**Avalon Rare Metals Inc.**

**RESPONSE TO THE DECEMBER 19, 2011 INFORMATION REQUESTS FROM  
FISHERIES AND OCEANS CANADA  
FOR THE THOR LAKE RARE EARTH ELEMENT PROJECT  
DEVELOPER'S ASSESSMENT REPORT**

**Submitted To:  
MACKENZIE VALLEY ENVIRONMENTAL IMPACT REVIEW BOARD**

**January 2012**

Figure 1

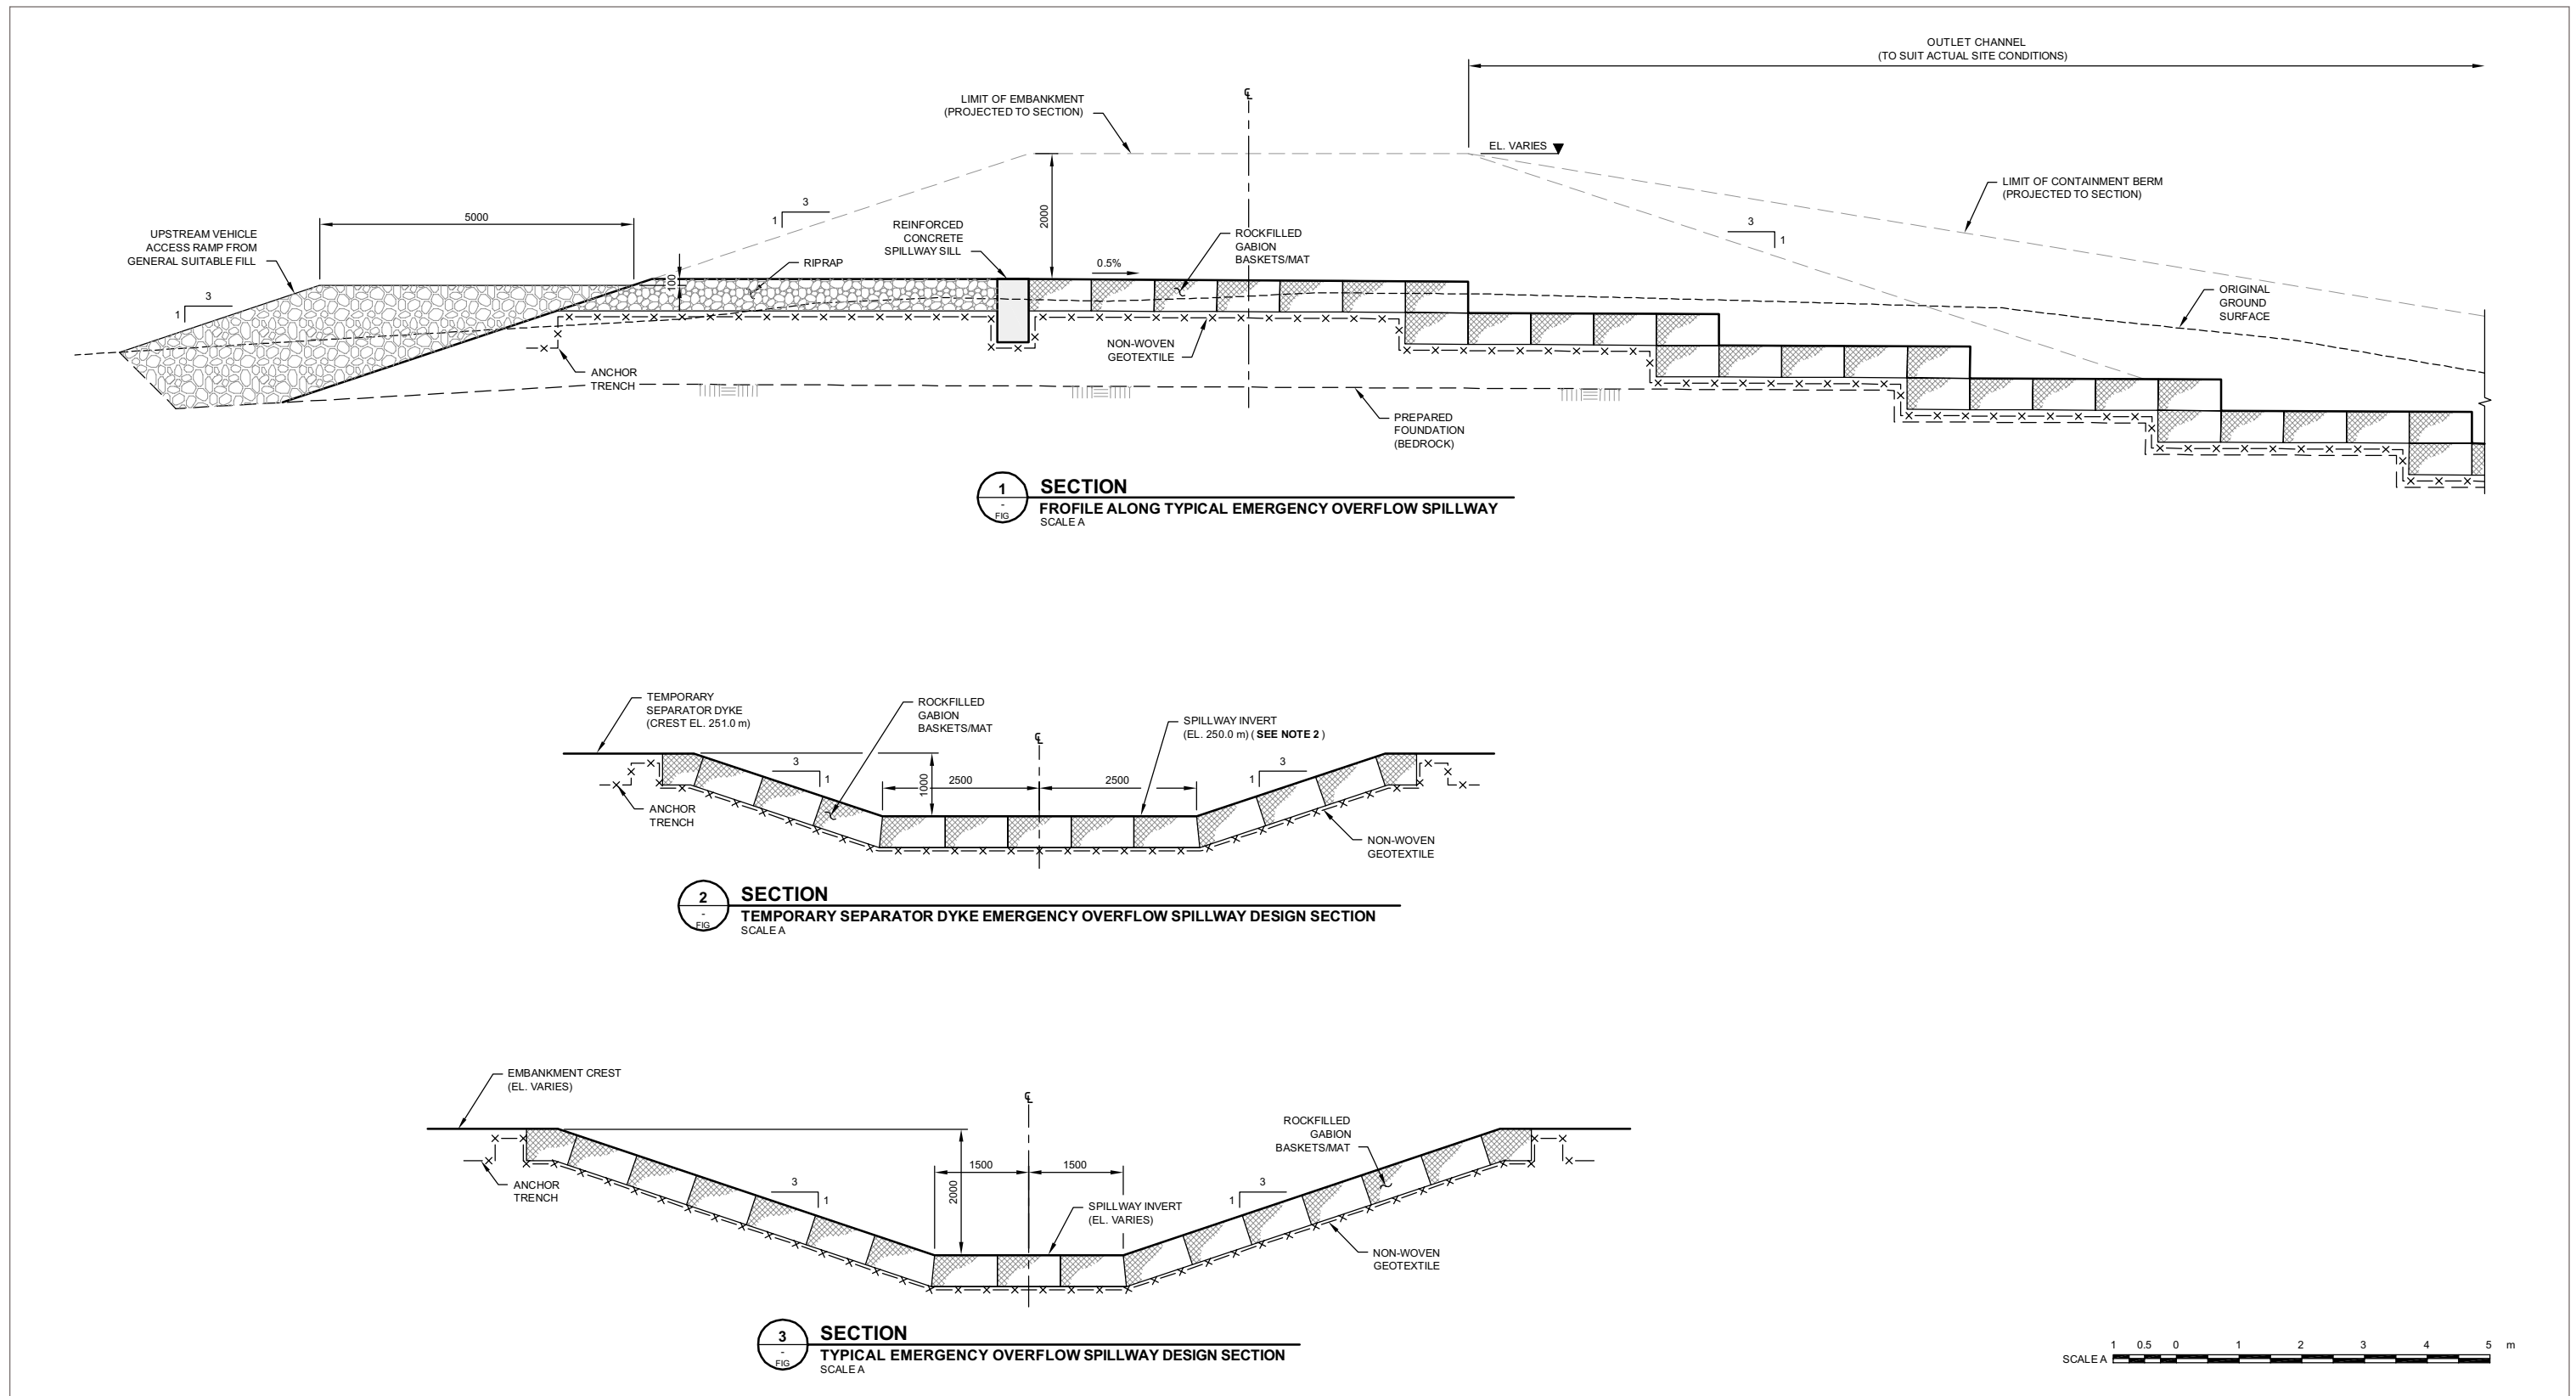
Various figures throughout the DAR (such as Figure 4.7-6) show an “emergency overflow spillway” from the polishing pond area of the TMF into Drizzle Lake however no details have been provided on the design or operation of this structure.

DFO requests that Avalon provide specific details on the intent, design, and operation of the “emergency overflow spillway” between the polishing pond and Drizzle Lake.

The TMF construction will be completed to ensure that there is always sufficient storage capacity available in the facility to avoid overtopping of the embankments and provide sufficient freeboard to safely accommodate the maximum operating pond and Environmental Design Storm (EDS) event, combined with wave run-up. Additionally, the Emergency Overflow Spillway is designed to safely pass the Inflow Design Flood (IDF) event during both operations and closure.

The spillways have been designed to safely pass the IDF plus a freeboard allowance for wave run-up. The spillways will consist of a trapezoidal channel constructed through the embankment crest near the abutment. The intent will be to establish the invert of the spillway and outlet channel into competent foundation materials (i.e. bedrock), where possible, and therefore some field determination of the actual location and alignment will be required. Should it not be feasible to establish the invert into competent bedrock, the spillway and channel will be lined with a combination of riprap, geotextiles and rock filled gabion baskets/mats. The typical design details for the emergency overflow spillways are shown in Figure 1.

Figure 2

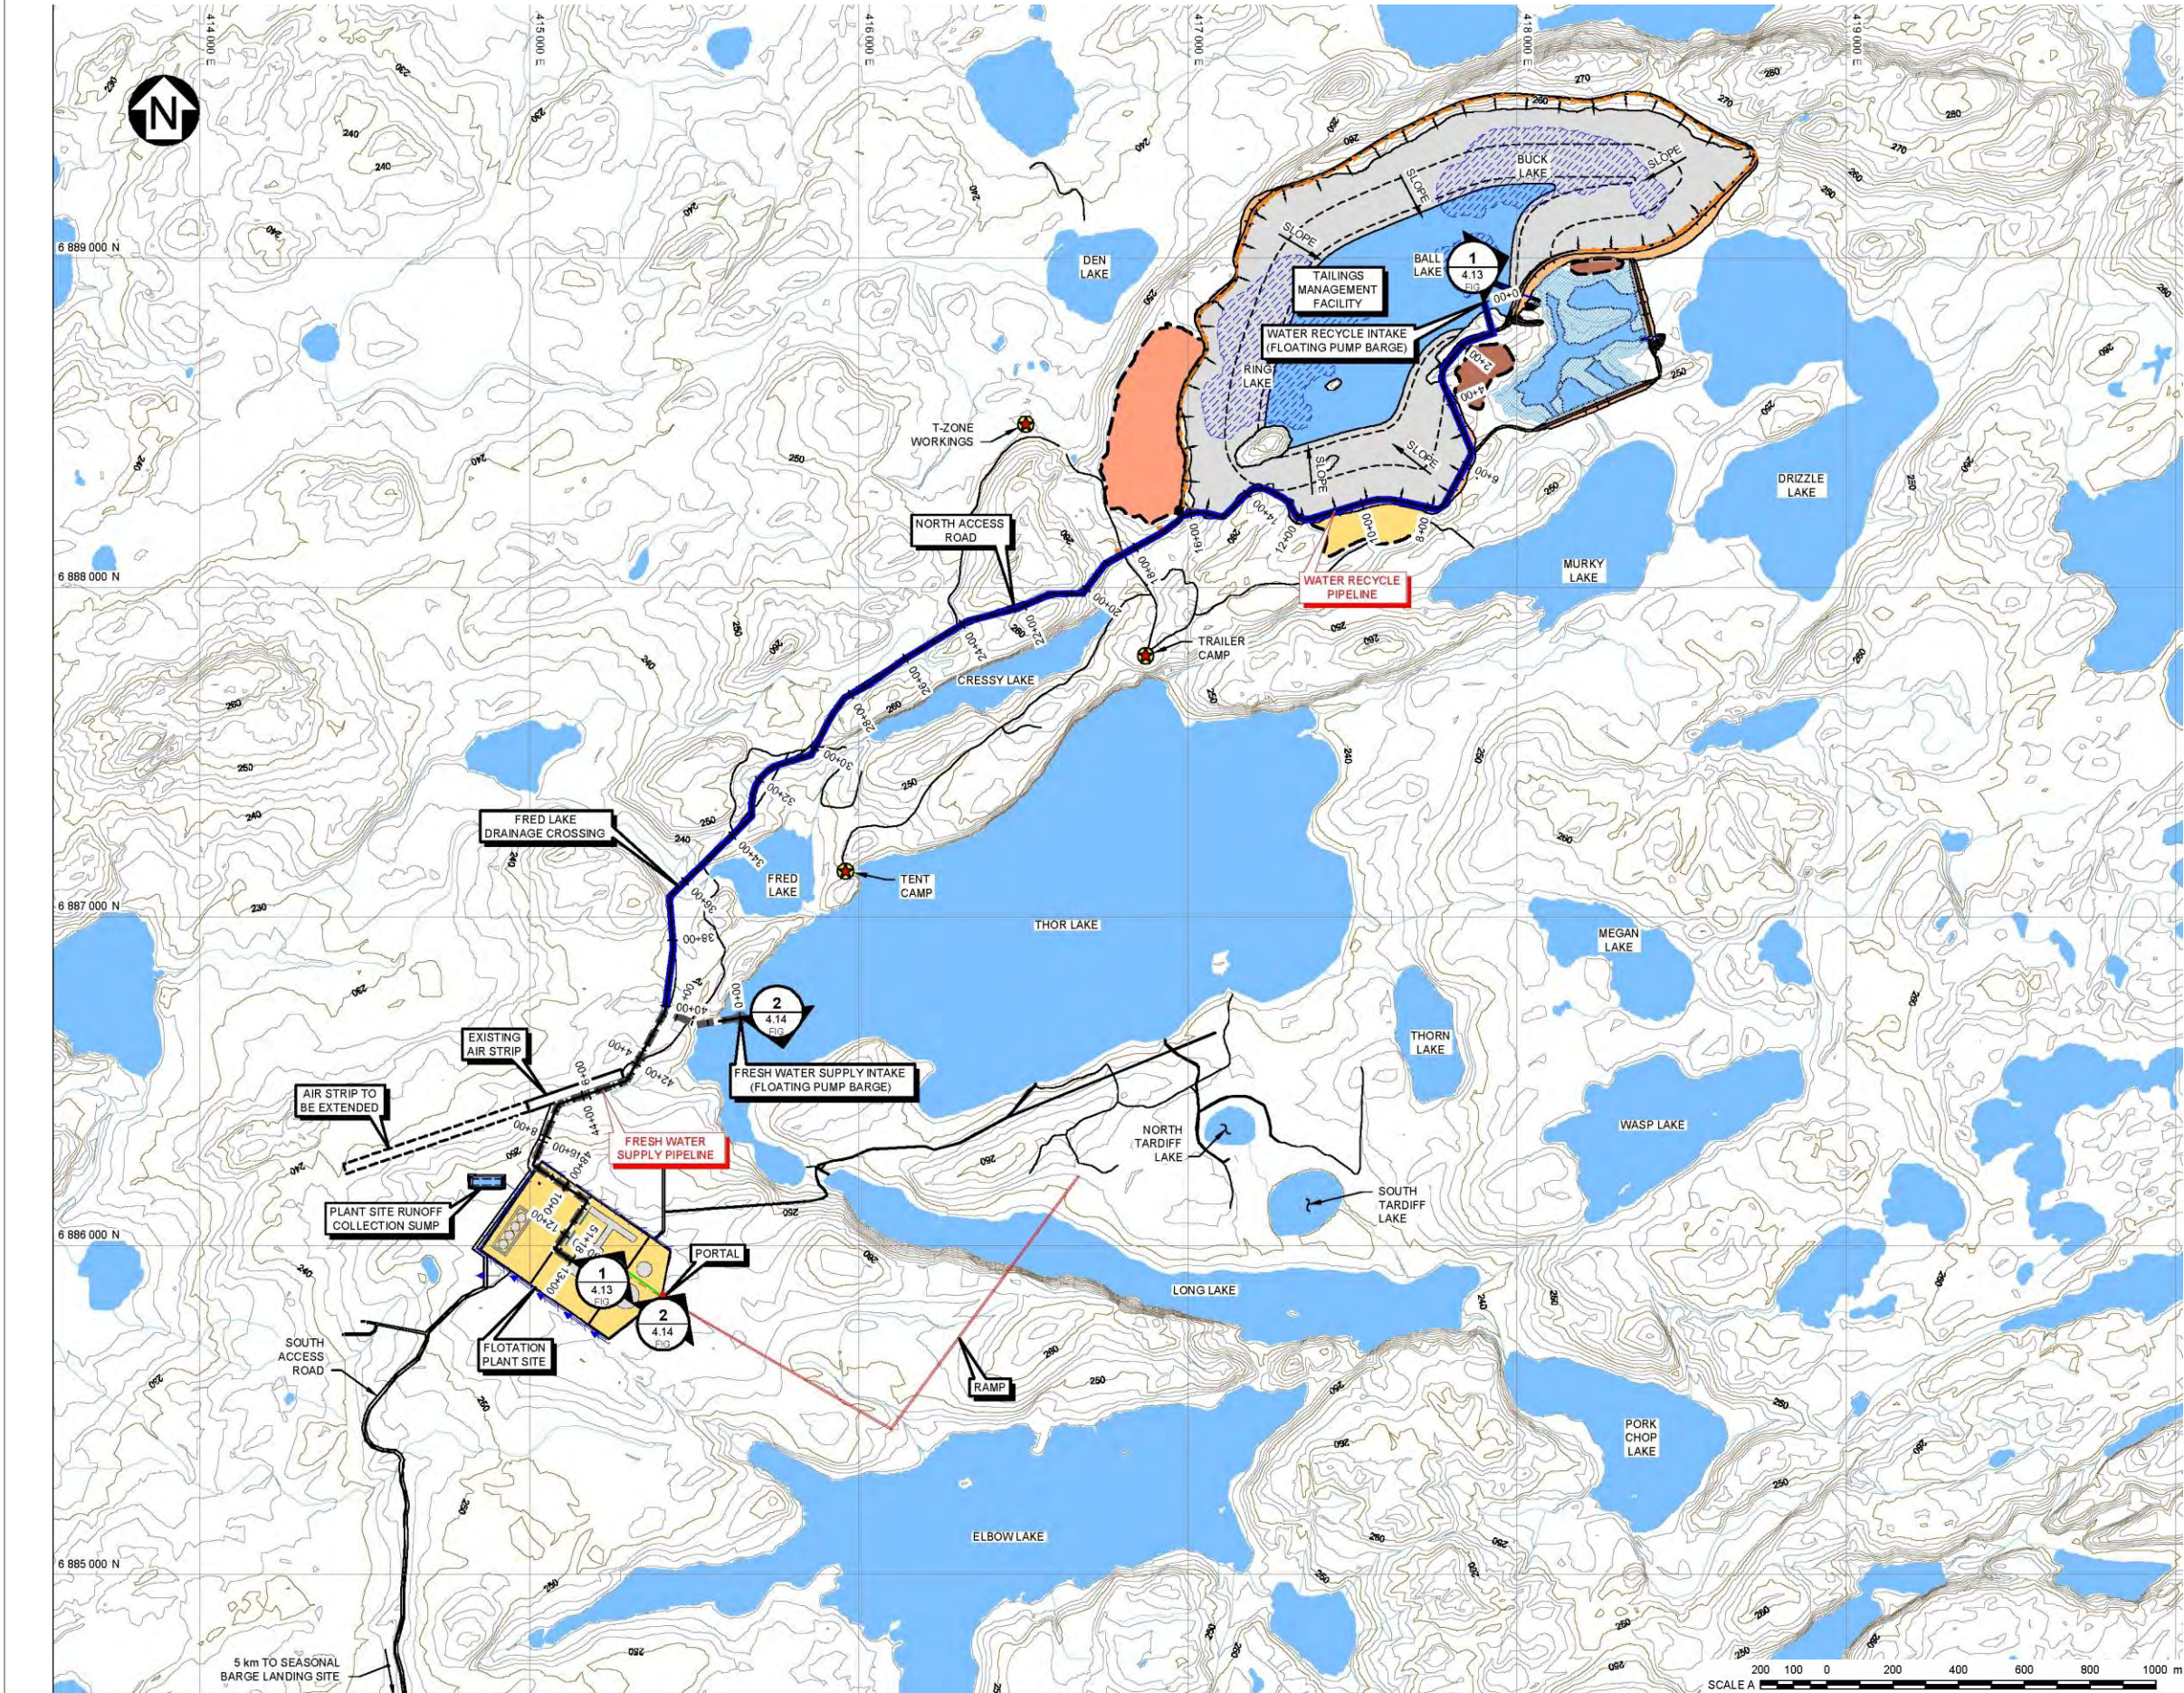
DFO recommends that Avalon provide conceptual designs of the water intake structure including precise location, installation methods, overall footprint, and a fish habitat assessment of the area, in order to assist in making any determination of potential impacts to fish and fish habitat.

The proposed fresh water supply source is Thor Lake and the proposed supply intake location is on the west end of Thor Lake shown in Figure 2, where the water depth exceeds 10 m. The supply intake will be placed in the deep area of Thor Lake and an appropriate fish screen will be employed in conformance with the Department of Fisheries and Oceans Freshwater Intake End-of-Pipe Fish Screen Guideline (DFO 1995). In addition, water withdrawal from Thor Lake will conform with the DFO Protocol for Winter Water Withdrawal in the Northwest Territories (DFO 2010).

The intake structure will be constructed as a pipeline that extends down the shoreline with a suspended pipeline (floating catwalk) out to the intake location (small barge). At the intake location (minimum of 10 m water depth) the intake pipe will extend vertically into the water column (above the lake bottom) to withdraw water. The general details for the barge and intake system are provided in Figure 3. As noted, the structure will be floating over the lake surface and will not be in contact with the lake bottom. As a result, no effects on fish or fish habitat are expected to occur.

Figure 4

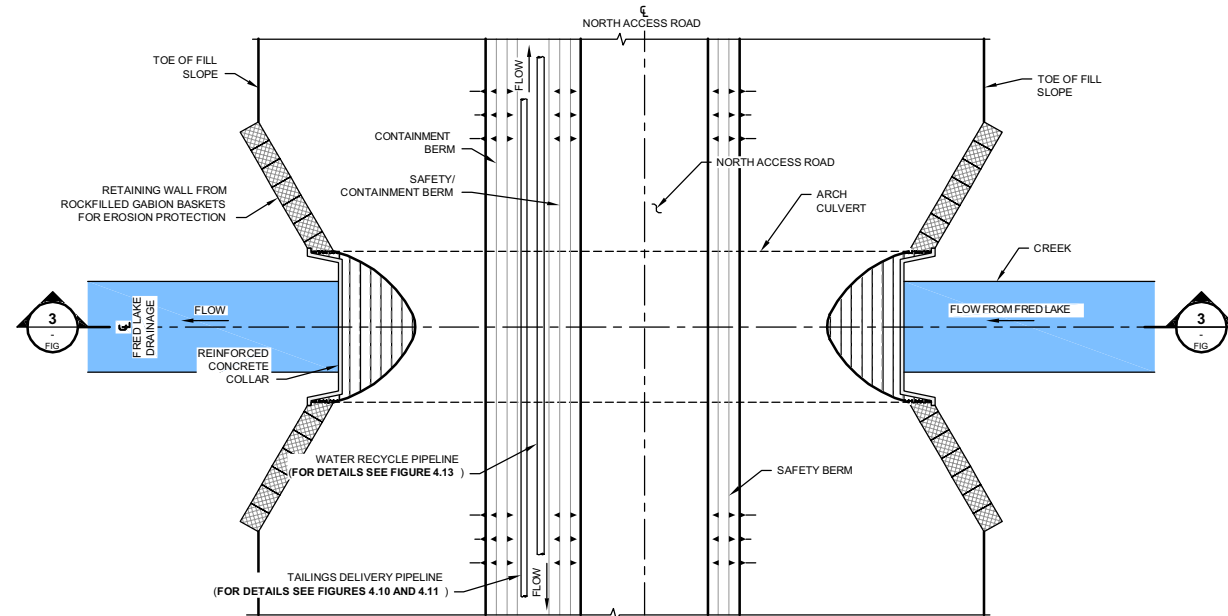
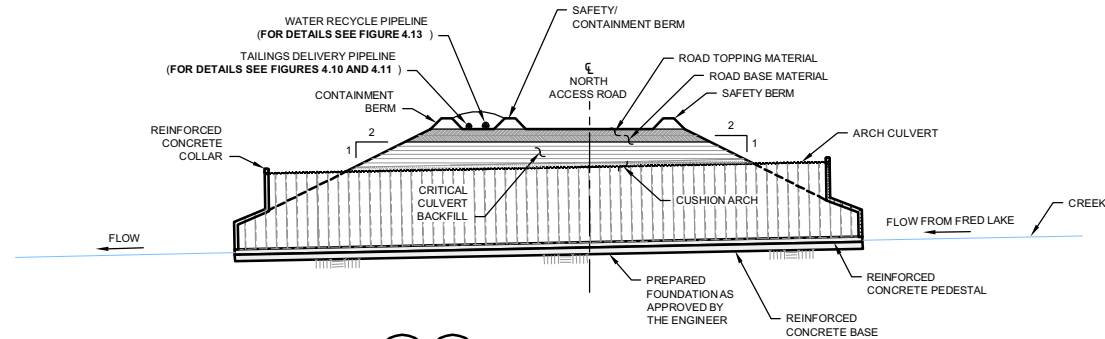
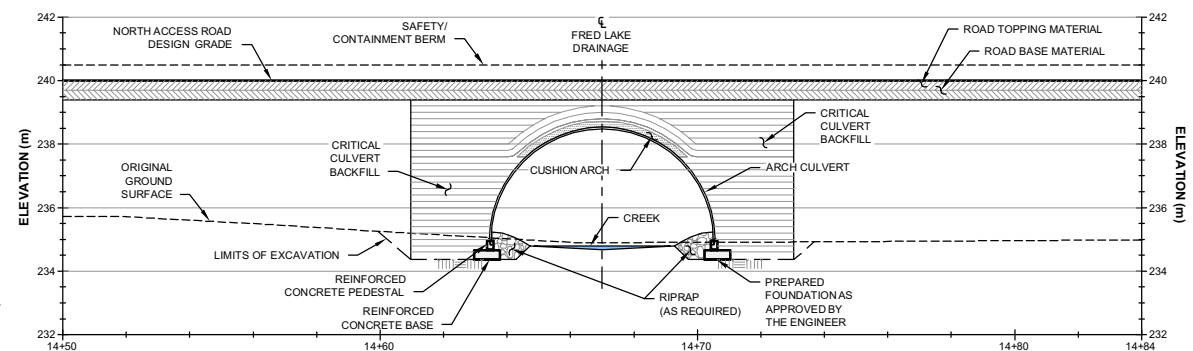
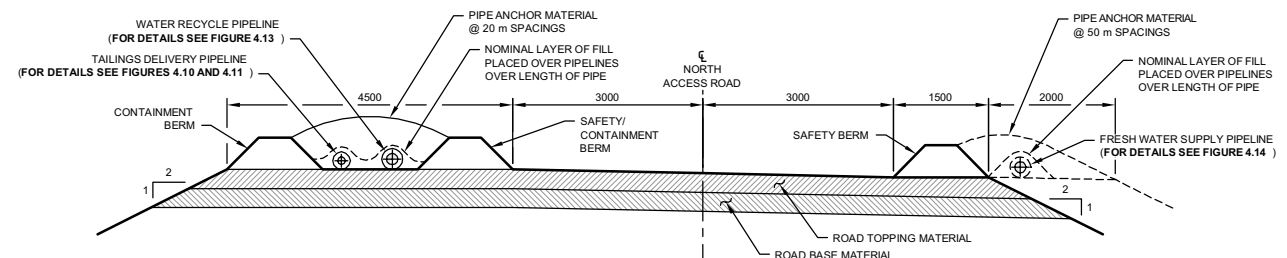
DFO requests additional details on all water course crossings, including any upgrades and/or proposed new crossings. This includes information on proposed designs, potential fish habitat impacts and mitigation.

Downstream of Fred Lake, the access road and pipeline route will pass over a creek, where an arch culvert will be placed in order to prevent impacts to the existing creek bed and to maintain continuous roadway with continuous pipeline containment (safety berms). Details for this crossing are included in Figure 4. During installation of the culvert and associated earthworks near the drainage, silt fences will be employed to prevent sediment reporting to the natural drainage courses.

As part of the DAR description, ventilation raises will be required to supply fresh air to the underground workings and act as primary emergency escapeway for workers. These raises are planned in the area between Thor Lake and Long Lake requiring single lane access during construction for installation and operations for periodic maintenance inspections. The existing crossing between Thor lake and Long Lake will need to be upgraded, and a similar arrangement as that proposed for the Fred Lake crossing, namely the use of an arch culvert would be employed to protect and maintain the existing fish habitat at this crossing site.
